COUNCIL ASSESSMENT REPORT

SYDNEY EASTERN CITY PLANNING PANEL

PANEL REFERENCE & DA NUMBER	PPSSEC-306 DA-2024/10 PAN-401918
PROPOSAL	Construction of a thirteen (13) storey co-living development, restricted to student accommodation, comprising 305 rooms and associated communal areas.
ADDRESS	13 A Church Avenue MASCOT NSW 2020 Lot 1 DP 547700
APPLICANT	The Trustee for Iglu Property Trust No. 216
OWNER	The Trustee for Iglu Property Trust No. 216
DA LODGEMENT DATE	23 January 2024
APPLICATION TYPE	Development Application
REGIONALLY SIGNIFICANT CRITERIA	Section 2.19(1) and Section 2 of Schedule 6 of State Environmental Planning Policy (Planning Systems) 2021 declares the proposal regionally significant development as general development with a capital investment value (CIV) over \$30 million.
CIV	\$ 64,064,474 (excluding GST)
CLAUSE 4.6 REQUESTS	FSR - Section 4.4 of the Bayside Local Environmental Plan 2021; and Parking – Section 68 of the State Environmental Planning Policy (Housing) 2021.

Council received Development Application No. DA-2024/10 on 23 January 2024 seeking consent for the construction of a thirteen (13) storey co-living development comprising 305 rooms and associated com

Figure 25: Proposed Setback to 19-21 Church Avenue

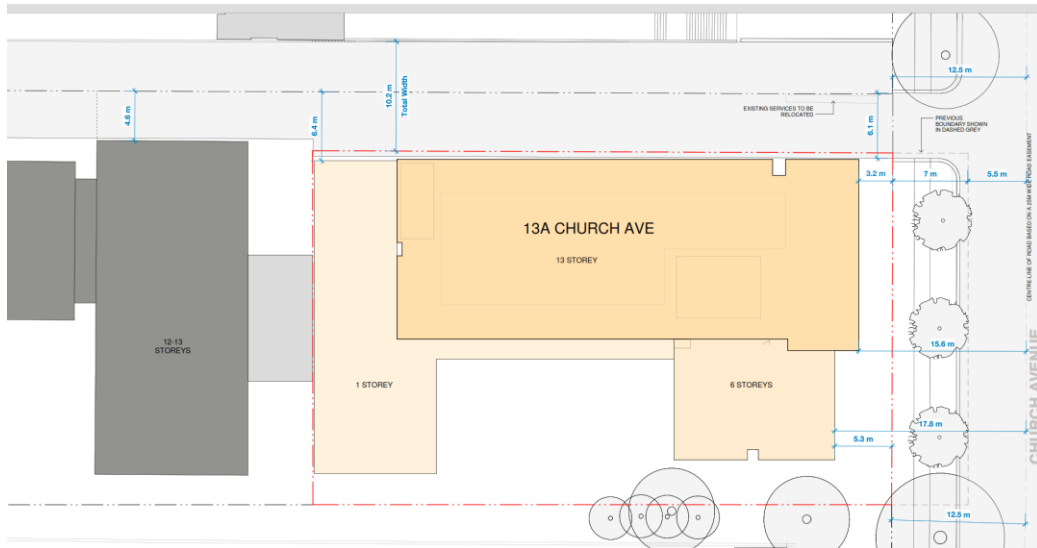
The proposal seeks to construct to the nil boundary setback along the entire length of the western elevation. This results in a variation of 6 Metres to a height of 12 Metres, 9 Metres to a height of 25 Metres, and 12 Metres for the remainder of the building façade.

Figure 32: Level 1 Floor plan

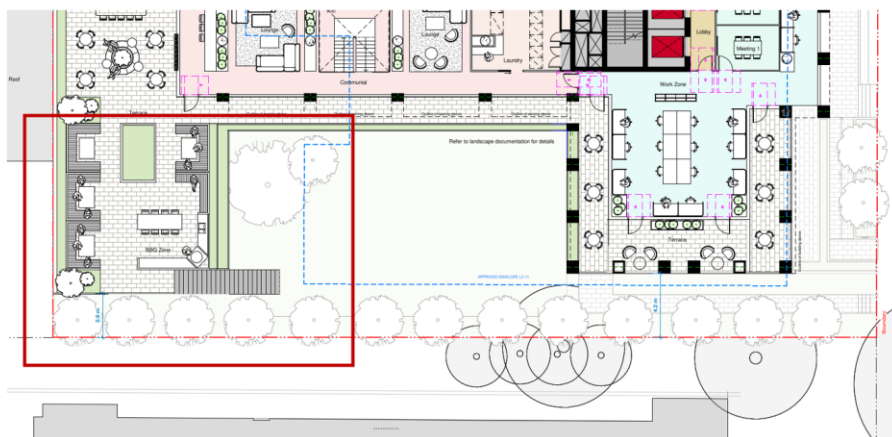
Notwithstanding the above, concerns have been raised by the Assessing Officer regarding the location of the communal open space on the first floor at the rear of the development, situated 2.9 Metres from the eastern boundary see Figure No. 30 and No. 31. Reference is also made to the BDCP 2022 which outlined that communal open spaces are required to be located away from habitable rooms of dwellings on adjoining properties.

While it is acknowledged that this area can only be used from 9am to 6pm, to ensure the development does not result in an unacceptable level of visual and acoustic privacy, this portion of the building will be required to be set back further into the site. The development must be set back 4.4 Metres to be consistent with the ground floor of the building below it. Additionally, it is suggested to include a planter box with a depth of 1 Metre to provide additional separation distances. Therefore, the steps access the ground floor open spaces will be setback at 5.5m from the boundary property allowing for an addition separation to the neighbouring building.

Figure 39 : Winter Solstice Sun Eye – 9am-12pm

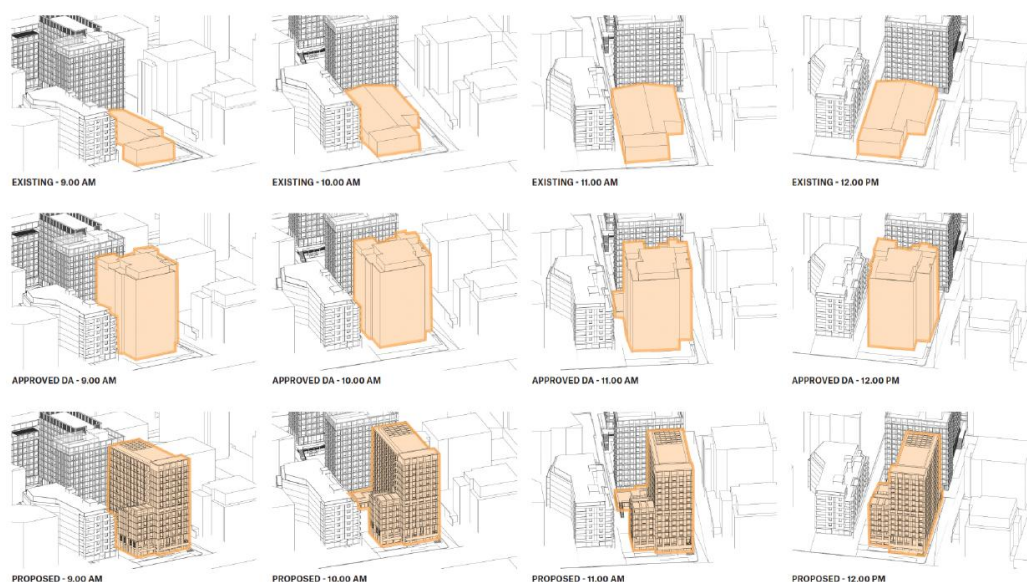
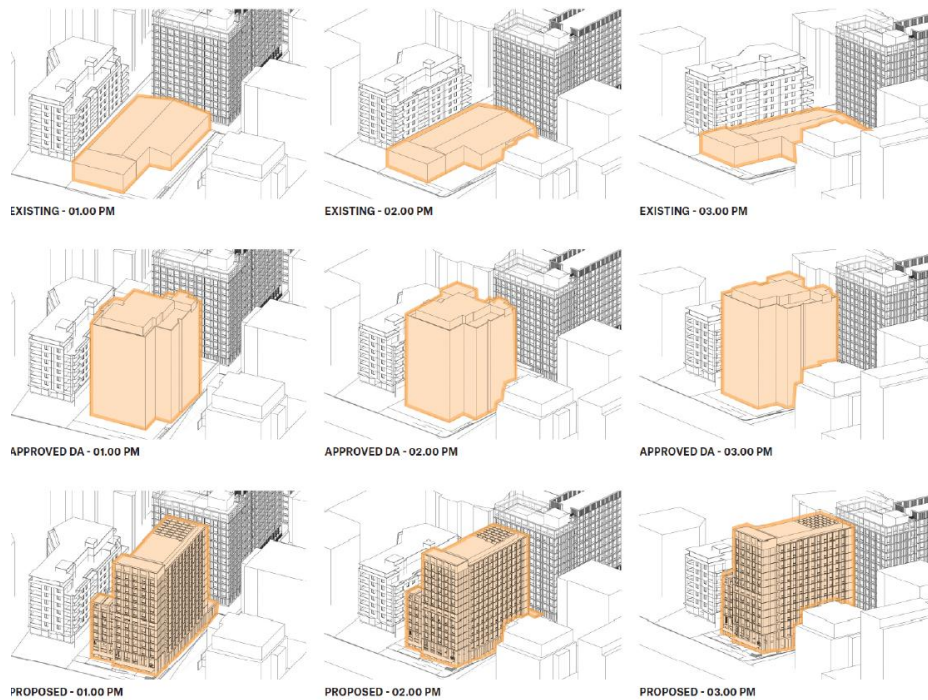
The proposed development has been sited and designed, as addressed above, to protect the adjoining neighbouring buildings solar access to living space and private open spaces. The application is supported by overshadowing diagrams at winter solstice, the spring equinox as well as view from the sun from 9 – 3pm for the winter solstice, spring equinox and summer solstice which is enough information to enable for a detailed assessment.

Due to the north-south orientation of the site, the units at 3-9 Church Ave will not be impacted by the development from 9am to midday. Similarly, the units at 19-21 Church Ave and their associated private open spaces will remain unaffected by the development from midday to 3pm. It is essential to clarify that overshadowing of one's own property is not considered when assessing the impact of overshadowing. With regards to the eastern and western neighbouring properties the developments meet the requirements of the BDCP 2022.

Figure 42: Road widening

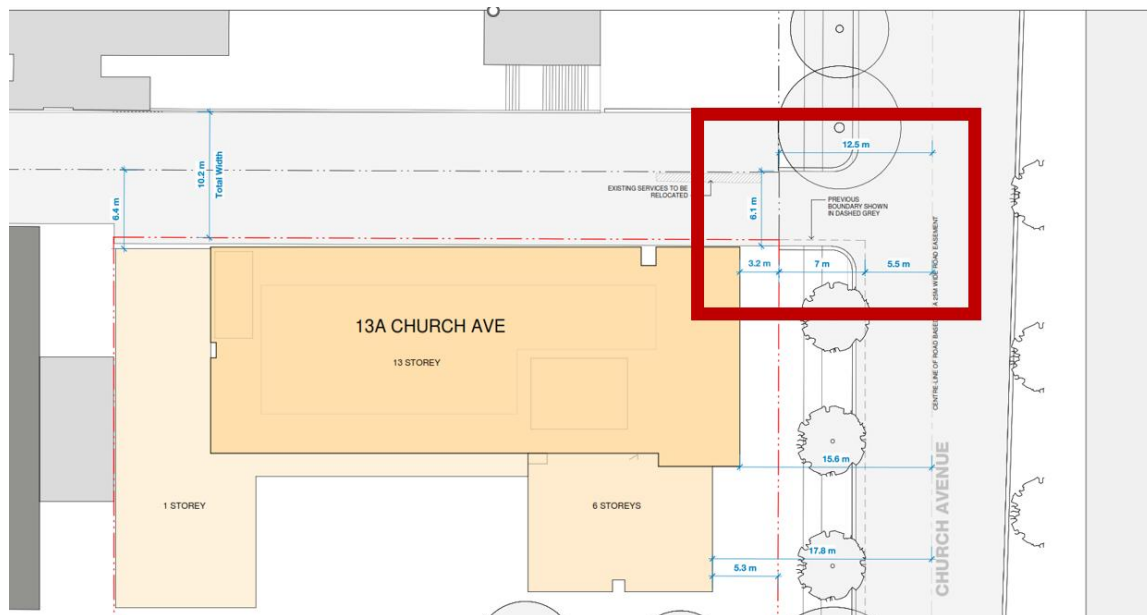
The proposal is required to deliver road widening along Church Avenue. The proposal has met these requirements as identified in Figure No. 42.

The applicant has successfully achieved this requirement, and the land will be dedicated to Council. The application has been appropriately conditioned to ensure the dedication of the land to Council.
